HISTORIC PRESERVATION COMMISSION

ALTERATION TO A HISTORIC PROPERTY STAFF REPORT

Site: 30 Day Street c. 1878 Eliza Stebbins House

Case: HPC 2013.049 Single Building Local Historic District

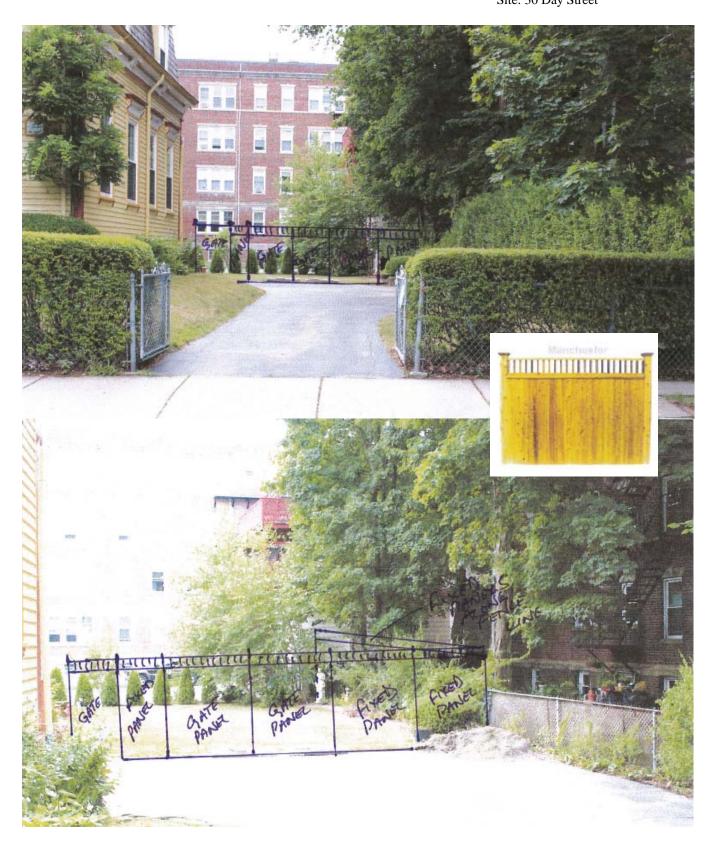
No changes to the features described in the Form B will be altered. The proposed fence will not obscure any part of the original structure.

Staff determines that the alteration for which an application for a Historic Certificate has been filed is appropriate for and compatible with the preservation and protection of the Single Building Local Historic District; therefore **Staff recommends that the Historic Preservation Commission grant 30 Day Street a Certificate of Appropriateness** for the installation of the board and baluster fence on the southern property line and across the rear of the driveway.
